Crank Change/Compatibility

A.C.™ Sport

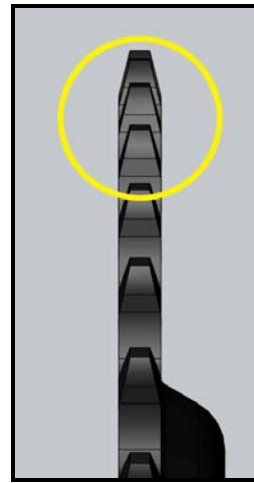
There was a change to the thickness of the crank sprocket, on the A.C. Sport, from 3/32" (2.1mm) to 1/8" (2.6mm). When this change was made, the chain and the flywheel sprocket had to be changed to make them compatible.

3/32" (2.1mm)

1/8" (2.6mm)

If any of these components are mismatched, there will be compatibility or timing issues between the cranks, chain and flywheel sprocket. So it is critical that the correct parts are ordered (based off the serial number of the bike).

Fig.1

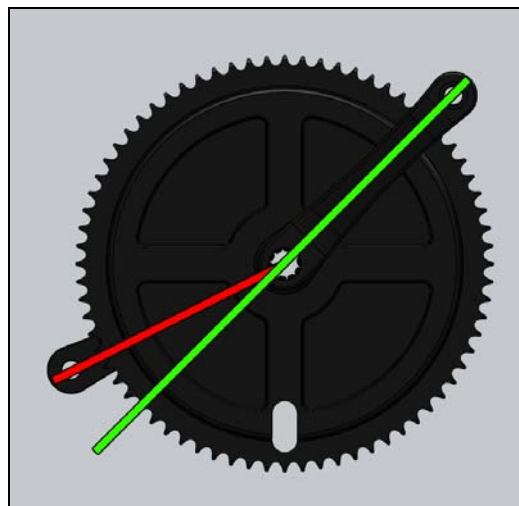
The timing between the 3/32" and 1/8" cranks are different. Should a 1/8" left crank be installed on a bike with a 3/32" right crank/sprocket, the arms will not be aligned (Fig. 1).
